LAND USE APPLICATION SUMMARY

Property Location: 35 Groveland Terrace
Project Name: 35 Groveland Terrace
Prepared By: Lindsey Silas, Senior City Planner, (612) 673-2653
Applicant: Mohsen and Julie Sadeghi
Project Contact: Craig Martin, Peterssen/Keller Architecture
Request: To allow a new three-story residential building with five dwelling units.
Required Applications:

Rezoning	Petition to rezone the property located at 35 Groveland Terrace from the R2 Multiple-Family District to the R3 Multiple-Family District.
Conditional Use Permit	To increase the maximum allowed height in the R3 District from 2.5 stories or 35 feet to 3 stories or 44 feet.
Site Plan Review	For a new residential building with five dwelling units.

1 ARCHITECTURAL SITE PLAN
SCALE: 1/8"=1'-0"

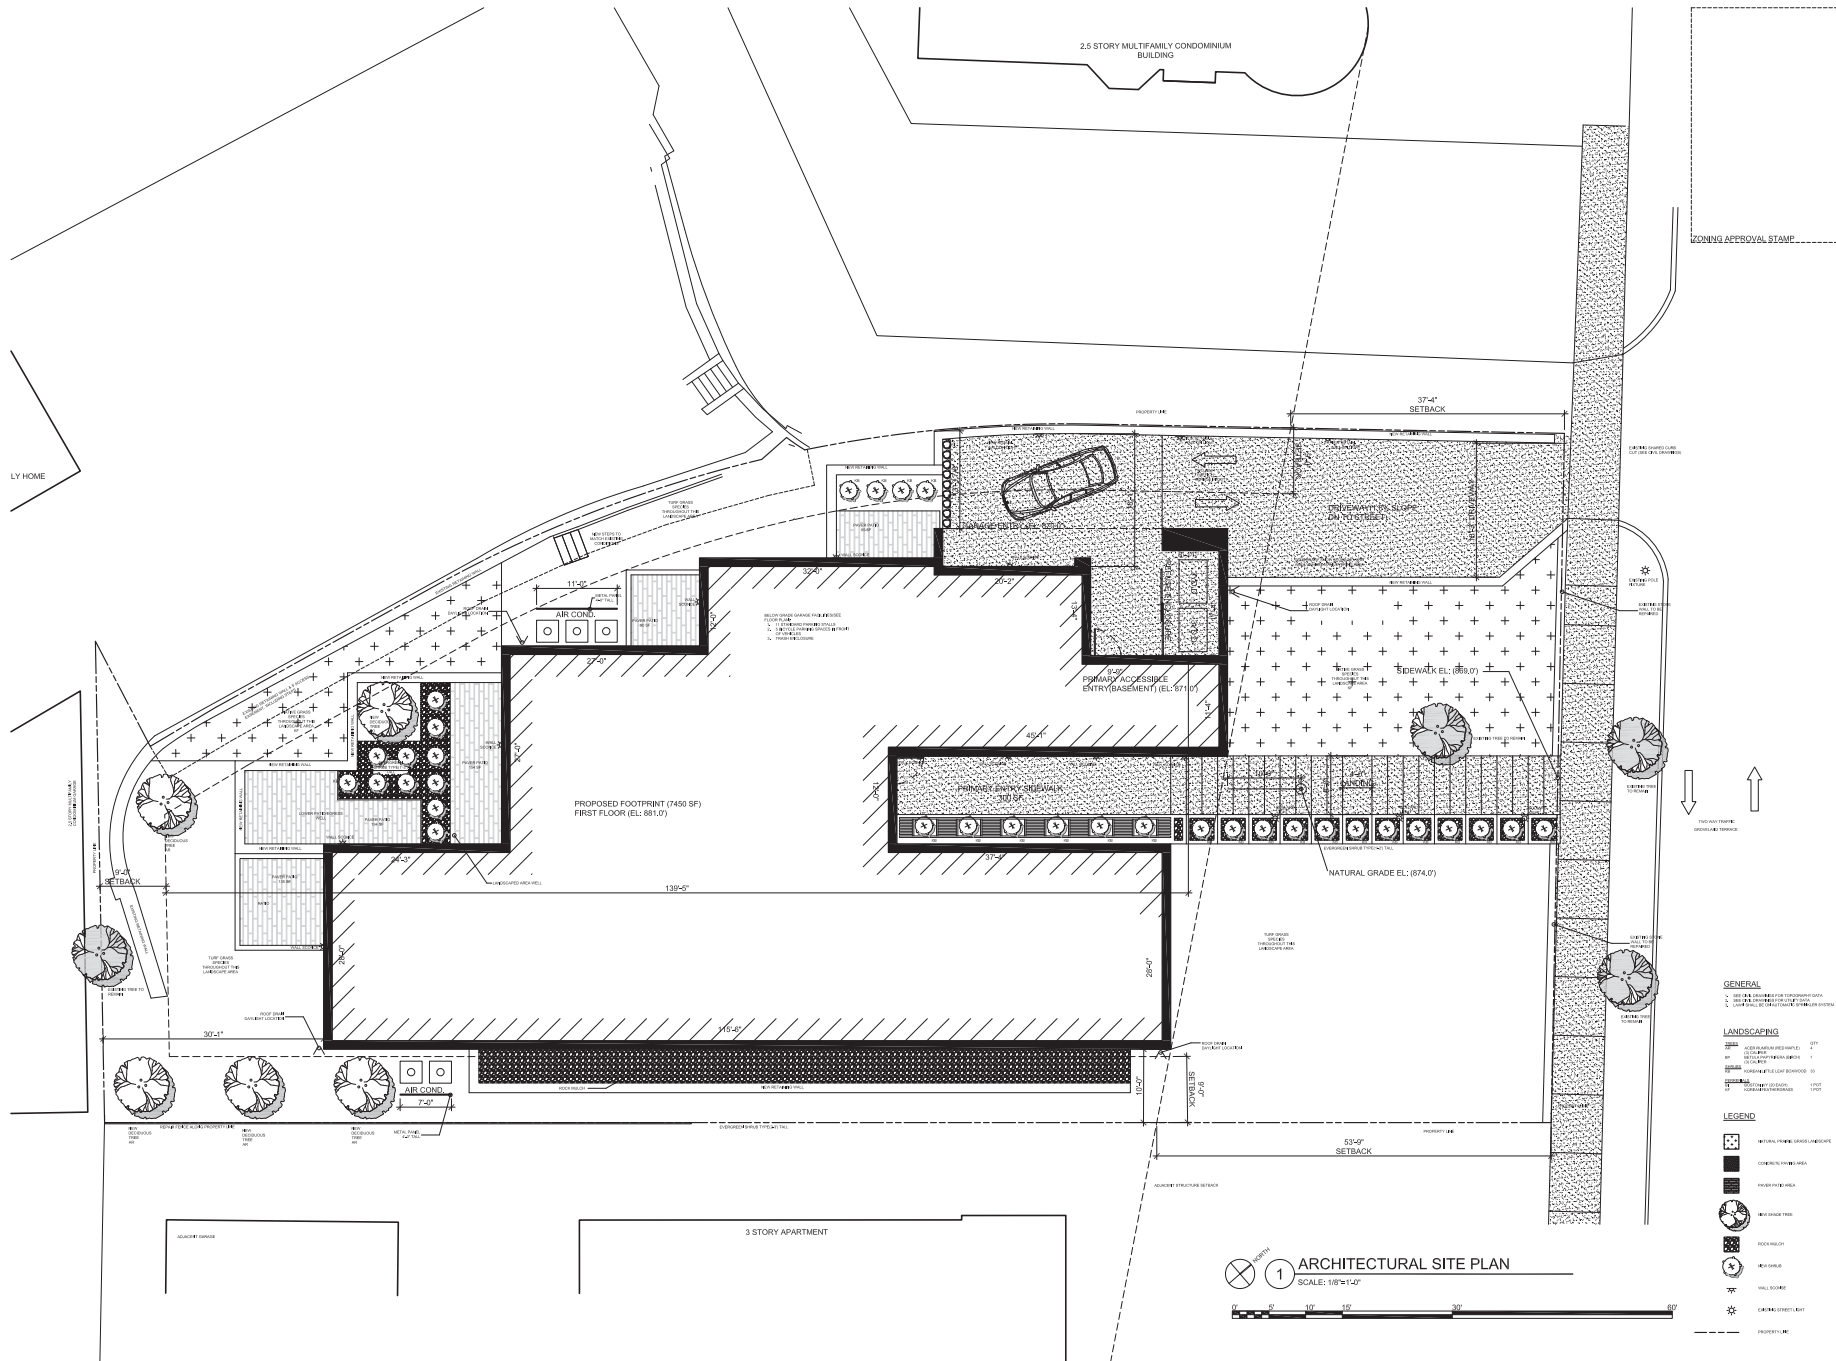
- There is an eight-foot wide walkway connecting the building with the public sidewalk.
- The applicant has not submitted a lighting plan. If the project were to be approved, staff would recommend a condition of approval that requires the final plans to demonstrate compliance with 530.130 of the zoning code

- The applicant did not submit a lighting plan showing entry way and walkway lighting. If the project were to be approved, staff would recommend a condition of approval that would require the final site plan to demonstrate how the entrances will be lit. As conditioned, the project would provide lighting on site, at all building entrances, and along walkways that maintains a minimum acceptable level of security while not creating glare or excessive lighting of the site.

A-200
ELEVATIONS

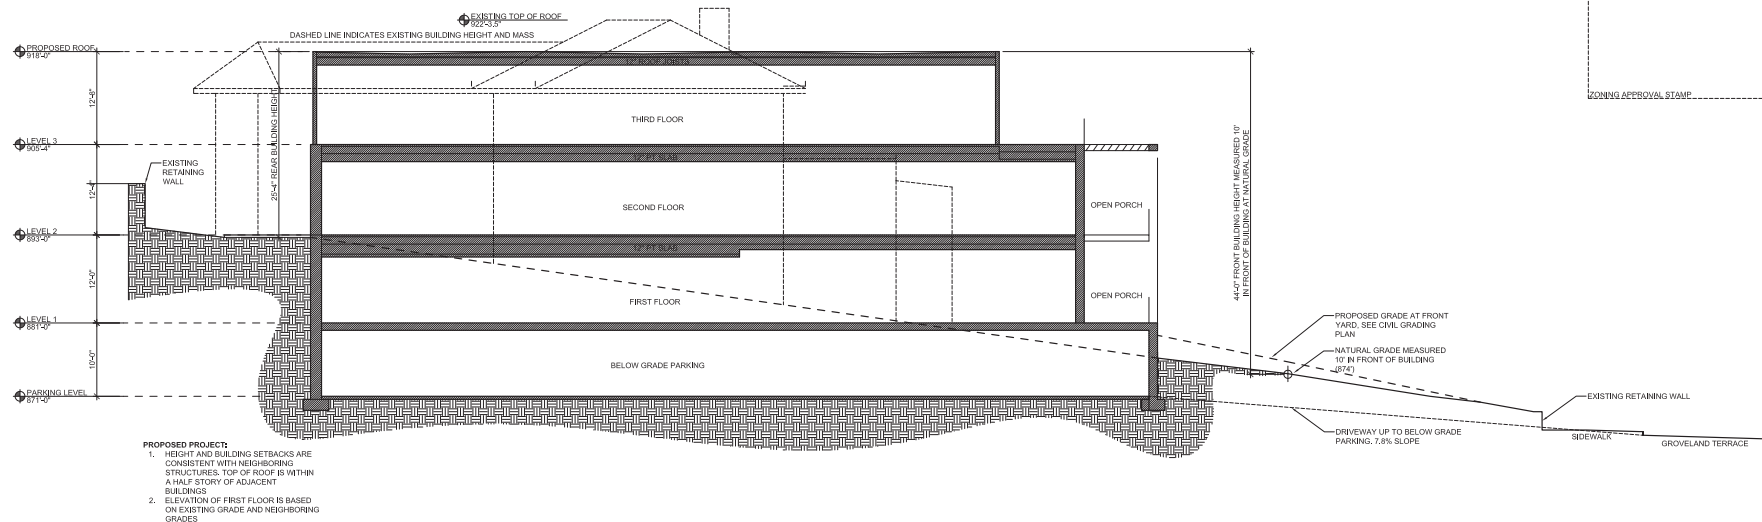
- The building walls provide architectural detail and contain windows in order to create visual interest.
- There are blank, uninterrupted walls exceeding 25 feet in length on the west elevation. Alternative compliance is required.

- **Visual interest.** There are blank, uninterrupted walls exceeding 25 feet in length on the second and third floors of the west elevation. The floor plans indicate that the blank walls are adjacent to living rooms and covered front-facing decks for two units. Staff finds that requiring compliance with this standard would not be unreasonable. If the project were to be approved, staff would recommend a condition of approval that there be no blank, uninterrupted walls exceeding 25 feet in length on the building.
